UNITED STATES
DEPARTMENT OF THE INTERIOR
BUREAU OF LAND MANAGEMENT

FORM APPROVED
OMB NO. 1004-0137
Expires: January 31, 2018**SUNDRY NOTICES AND REPORTS ON WELLS**
*Do not use this form for proposals to drill or to re-enter an abandoned well. Use form 3160-3 (APD) for such proposals.***HOBBS OCD**
NOV 27 2017
RECEIVED**SUBMIT IN TRIPLICATE - Other instructions on page 2**

| 3a. Address P O BOX 4294 HOUSTON, TX 77210-4294 | 3b. Phone No. (include area code) Ph: 432-685-5717 | 8. Well Name and No. MK STEWART 10 |

**** BLM REVISED ** BLM REVISED ** BLM REVISED ** BLM REVISED ** BLM REVISED ******FOR RECORD ONLY**
MW/OCD 11/27/2017

OXY USA Inc. - Proposed
M.K. Stewart #10
API No. 30-025-33963

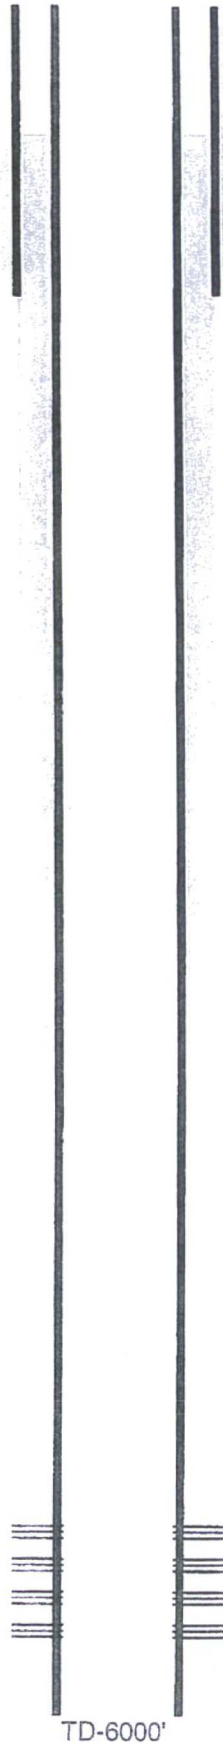
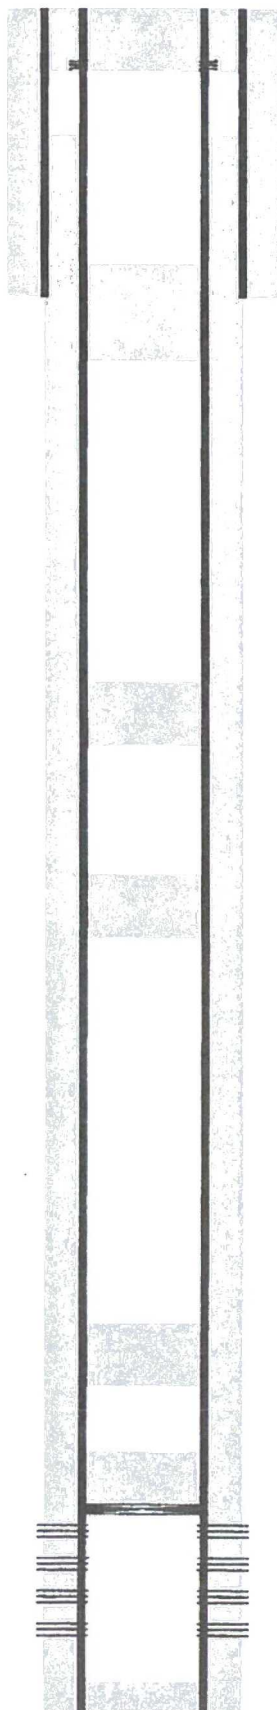
3934 - 3794 (San Andres)**RECLAMATION PROCEDURE
ATTACHED***Note: Tags on 2 & 3 are note
required tags unless conditions warrant.*

1. RIH & set CIBP @ 5381', M&P 25sx cmt to 5216'
2. M&P 25sx cmt @ 4986-4821' WOC-Tag
3. M&P 25sx cmt @ 3426-3261' WOC-Tag
4. M&P 25sx cmt @ 2651-2486' WOC-Tag
5. M&P 30sx cmt @ 1180-965' WOC-Tag
6. Perf @ 300', sqz 95sx cmt to surface
- 10# MLF between plugs
